Product Discontinuance Notification—PDN# 0000445504
June 24, 2026

We would like to inform you that the NPort 6000 and CN2500/CN2600 will reach its End of Life (EoL) phase, starting May 01, 2026.

Specification	NPort 6150 (EoL)	NPort 6150-G2 (Replacement)
Dimensions (with ears)	90 x 111.8 x 29 mm

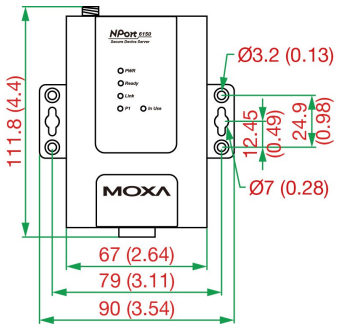
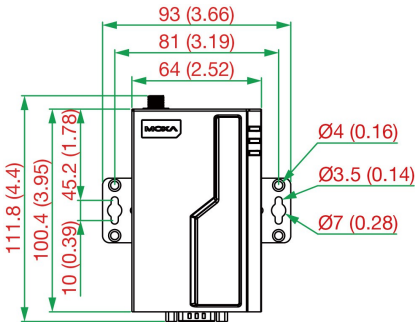
93 x 111.8 x 25 mm

Specification	NPort 6600-8/16/32 (EoL)	NPort 6600-8/16/32-G2 (Replacement)
Dimensions (with ears)	200 x 480 x 44 mm

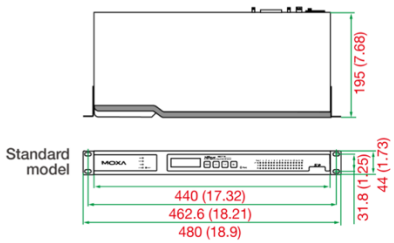
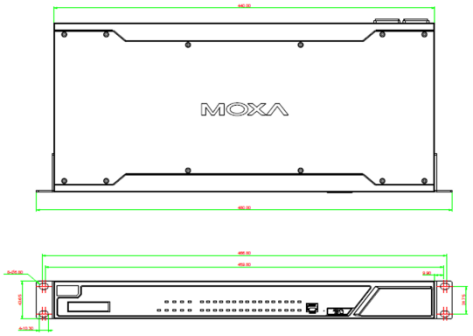
200 x 480 x 43.65 mm
